5722 APARTMENTS

SDCI Project #3036025-LU

Recommendation Meeting | REC
Southeast Design Review Board

VIEW FROM NORTH ON MLK JR WAY S

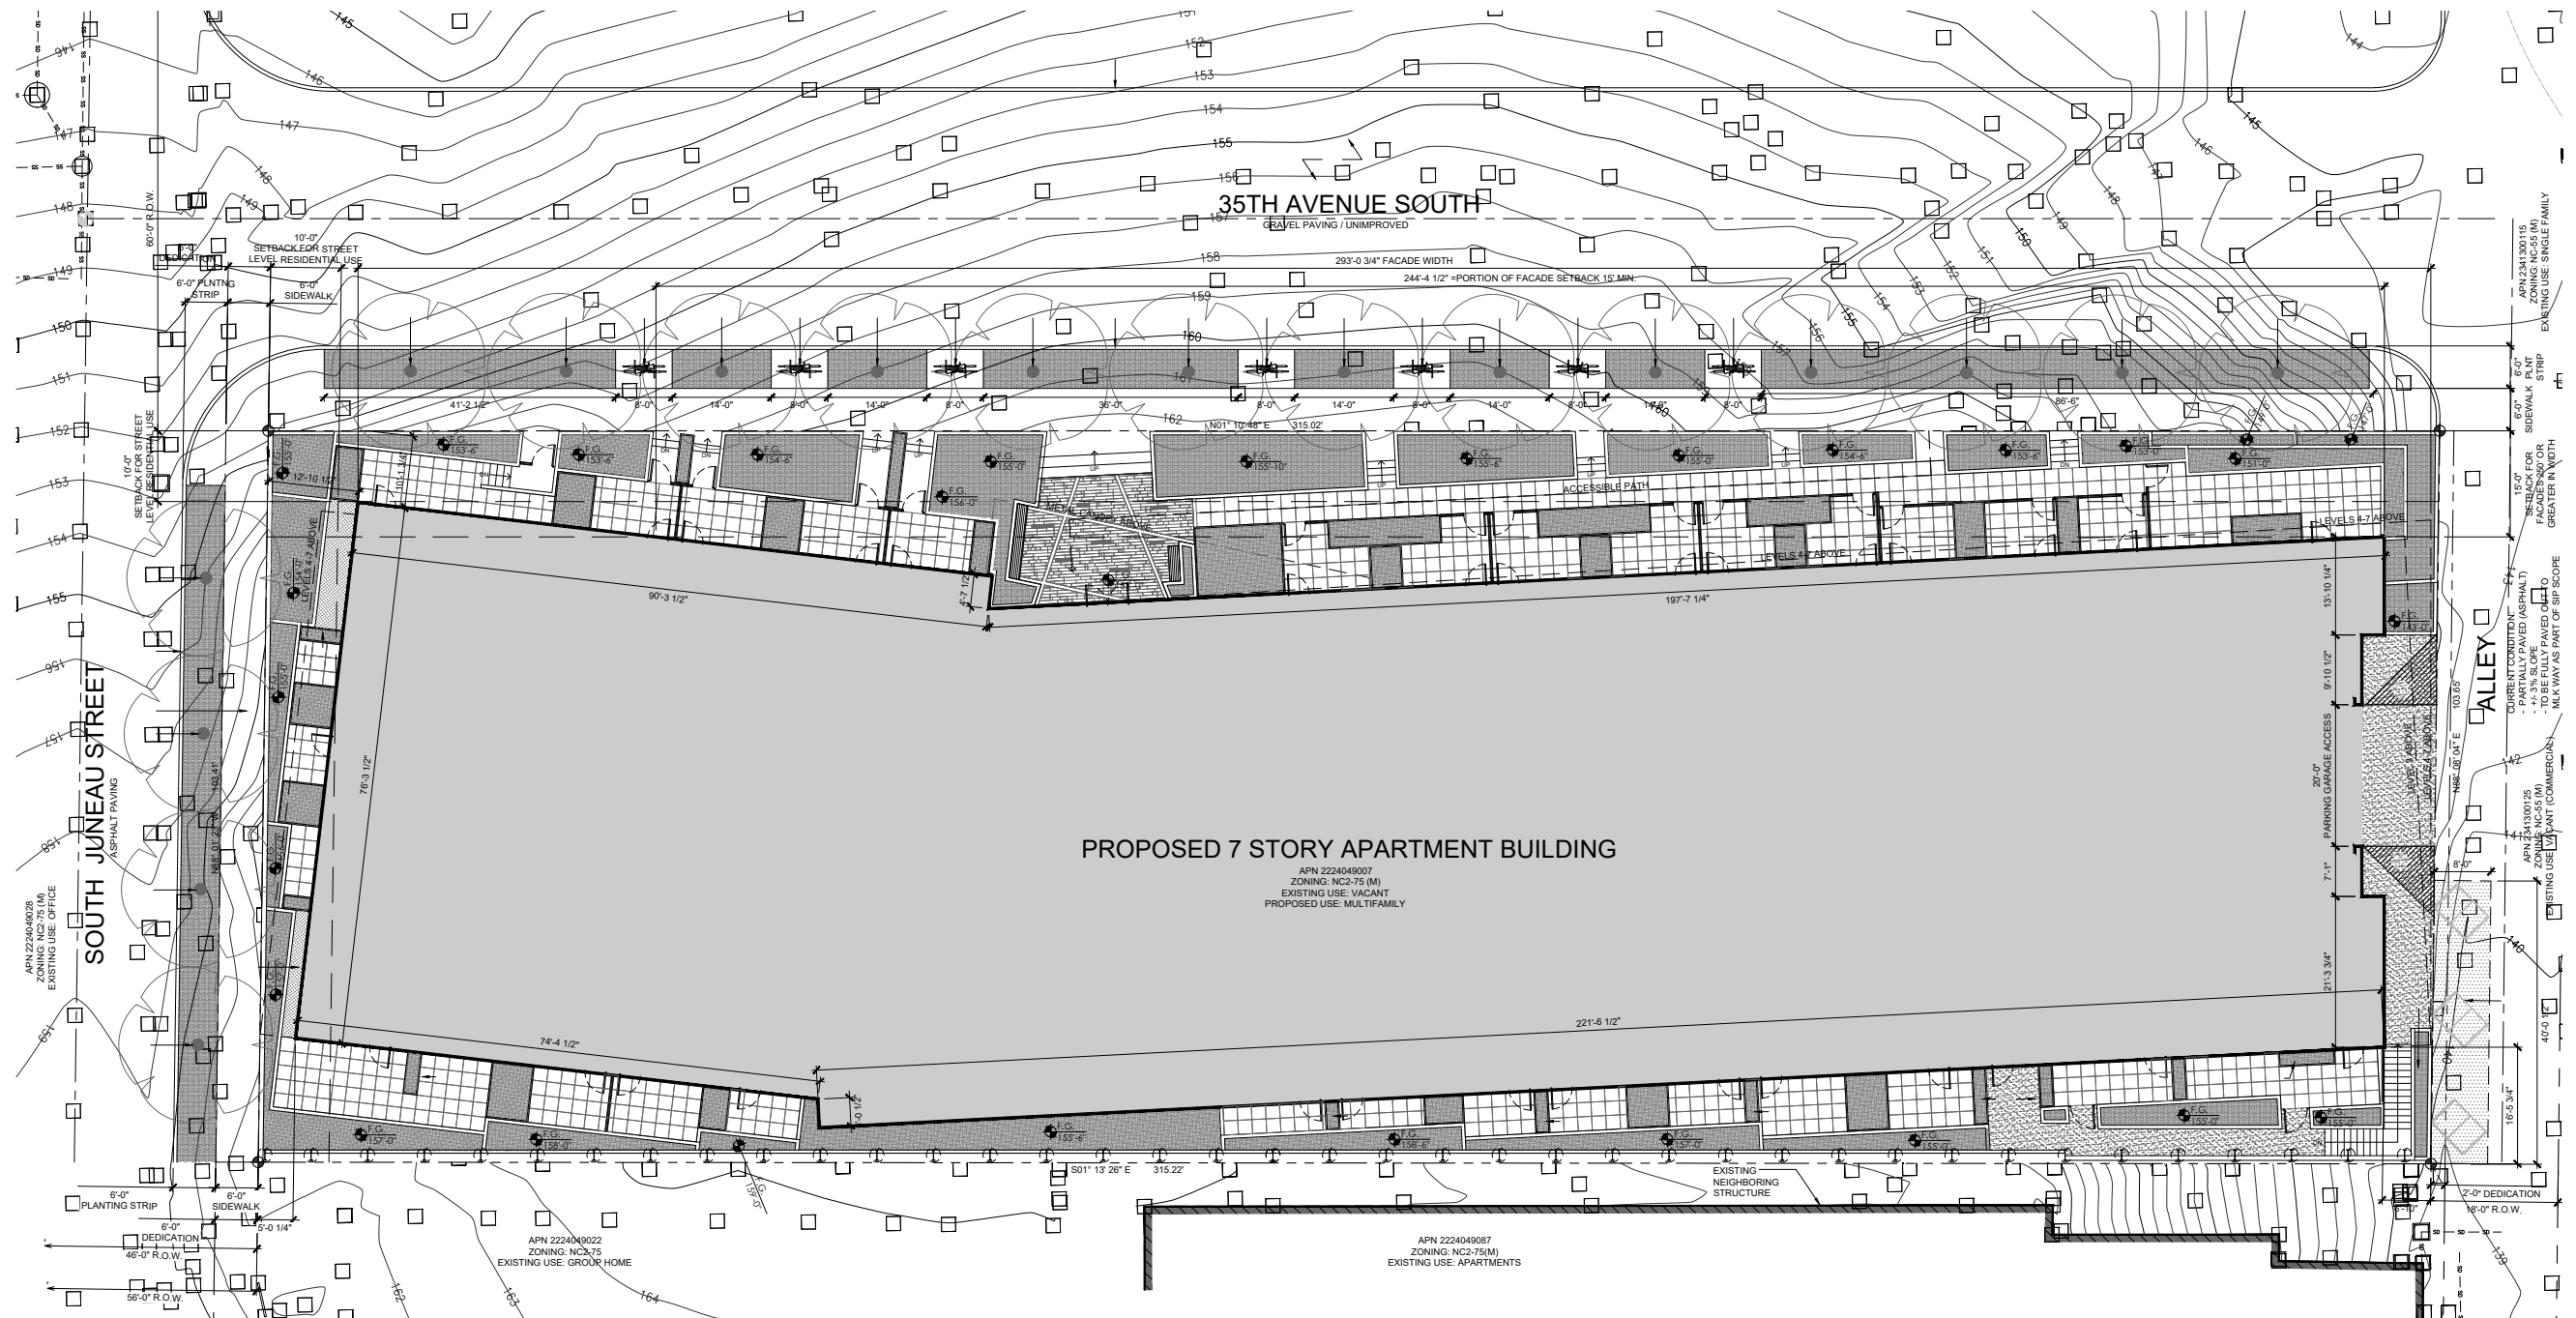
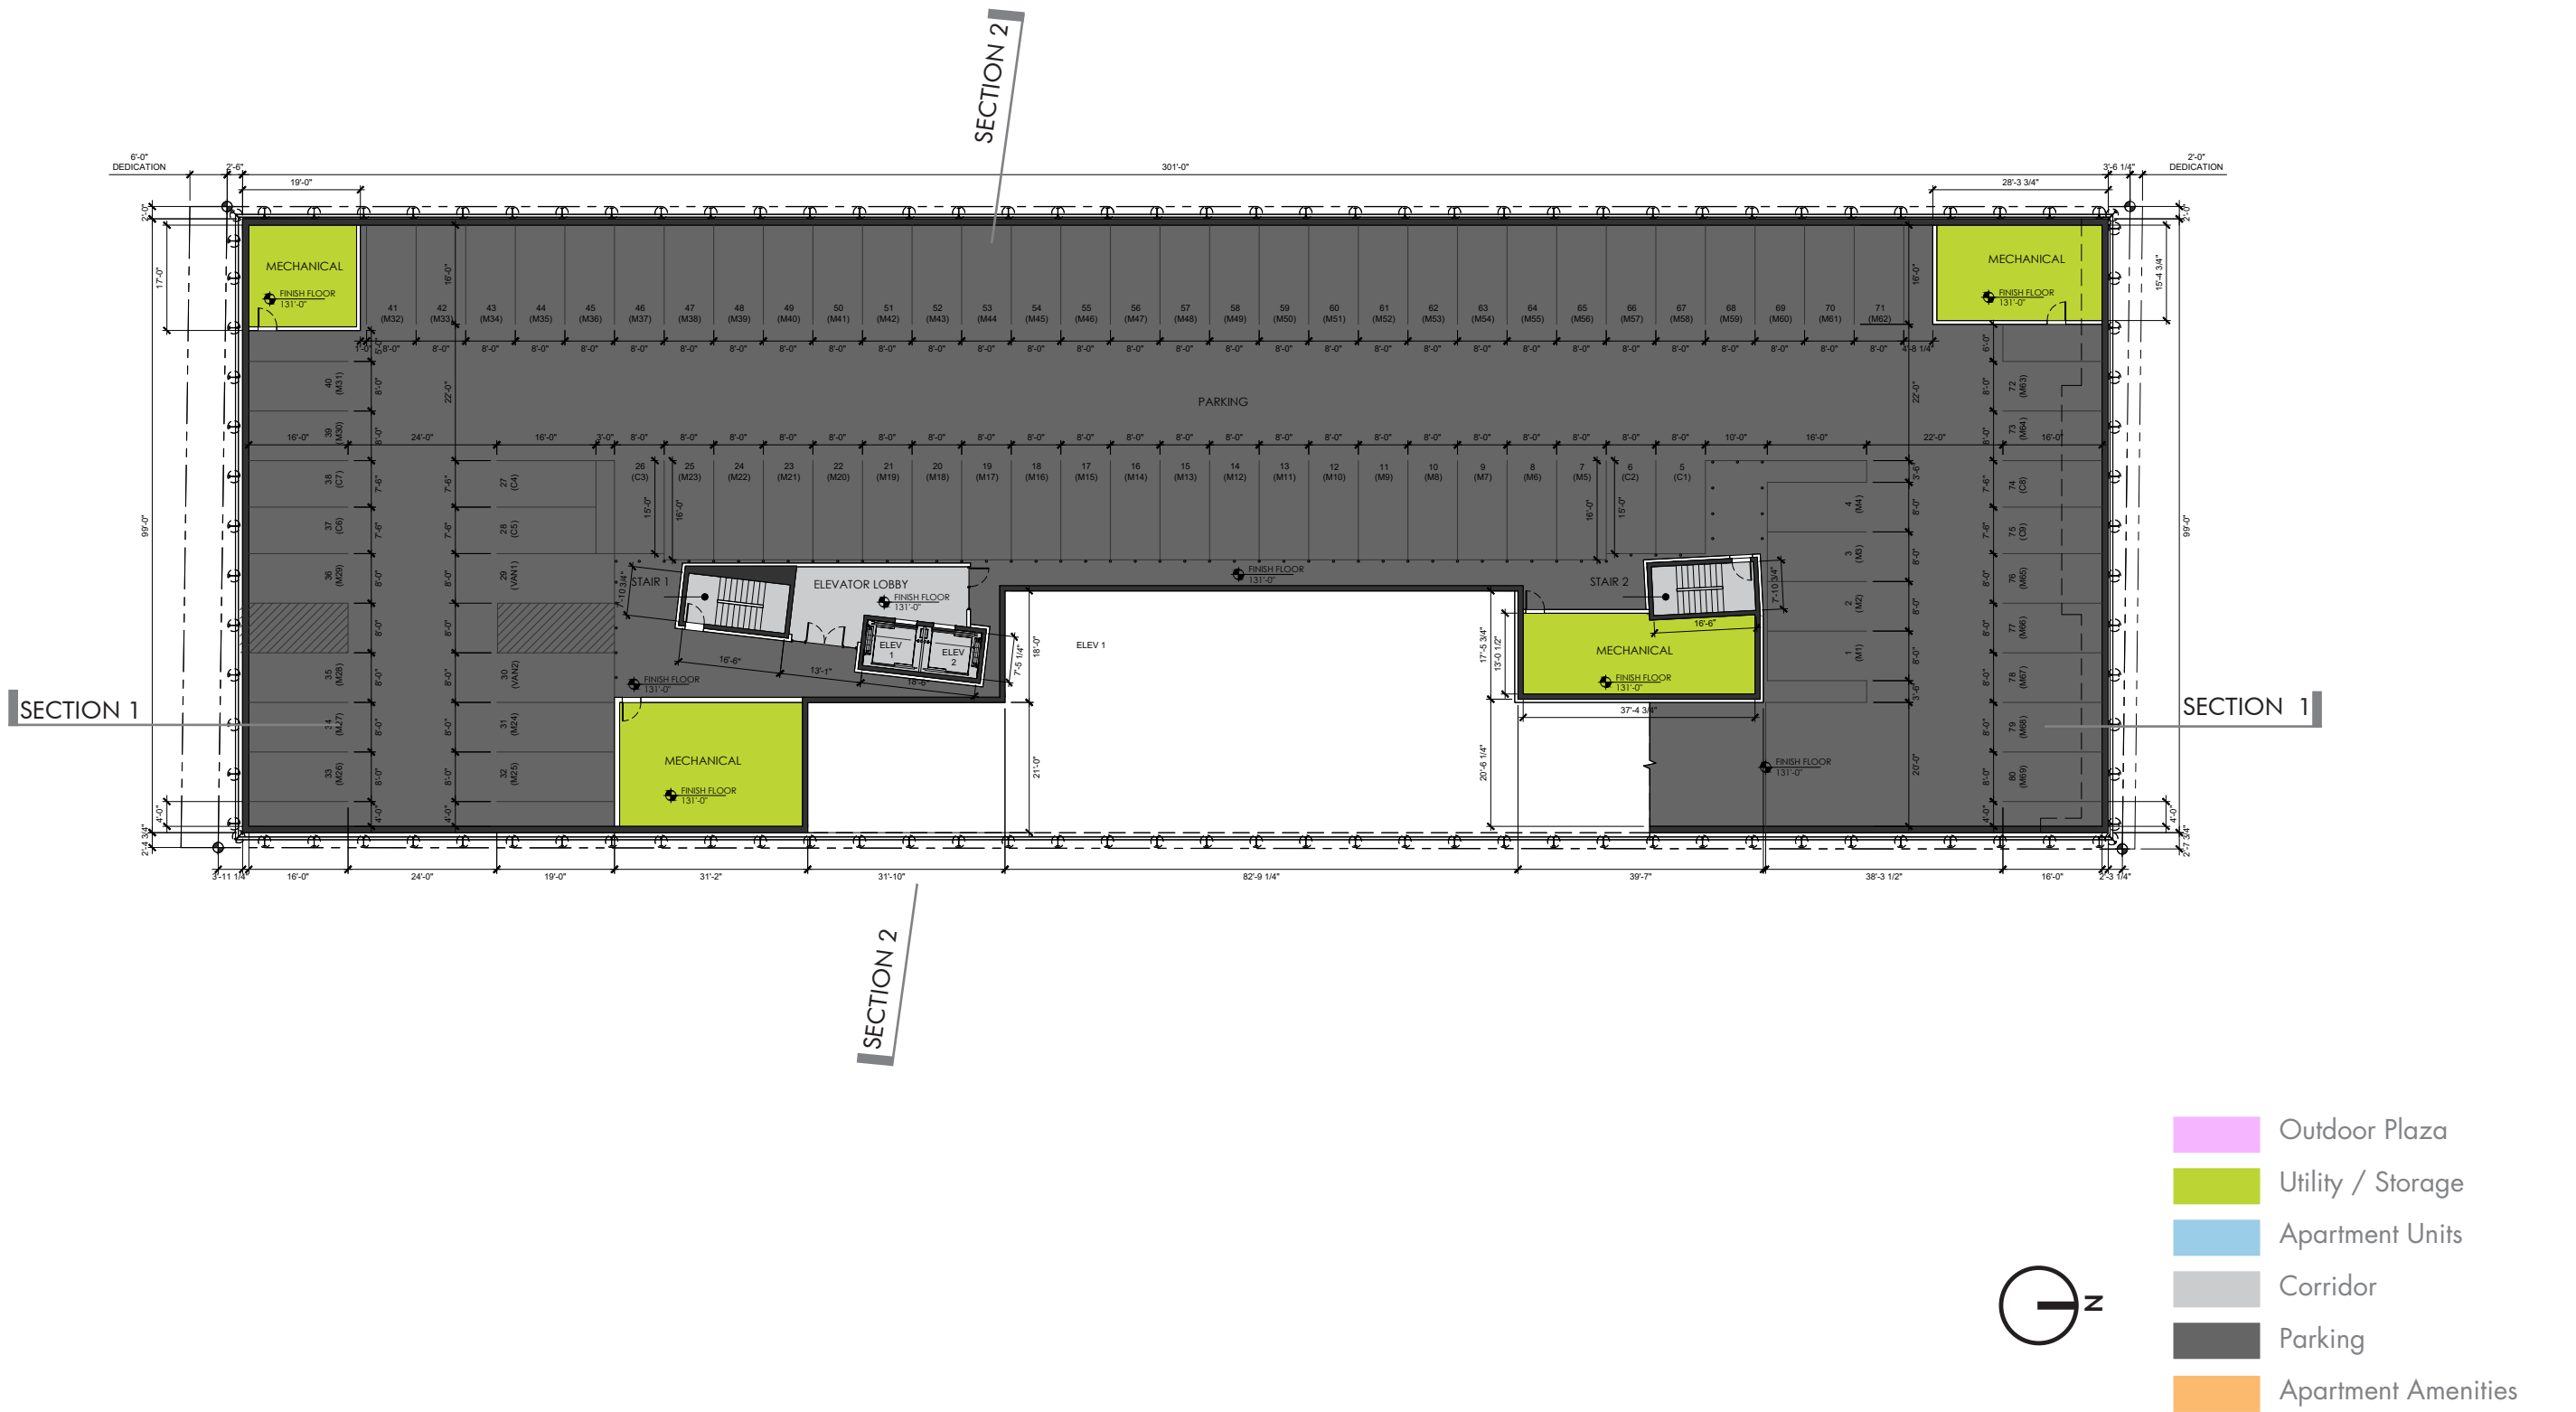
b. Board Members indicated that, given the scale of the proposed building, a view from MLK Blvd should be included with the recommendation packet. CS2-II

A perspective view MLK Blvd is provided in the packet. As shown, the proposed project is hardly visible from MLK as a result of the drastic elevation change and the heavy vegetation between MLK JR WAY S and the project site.
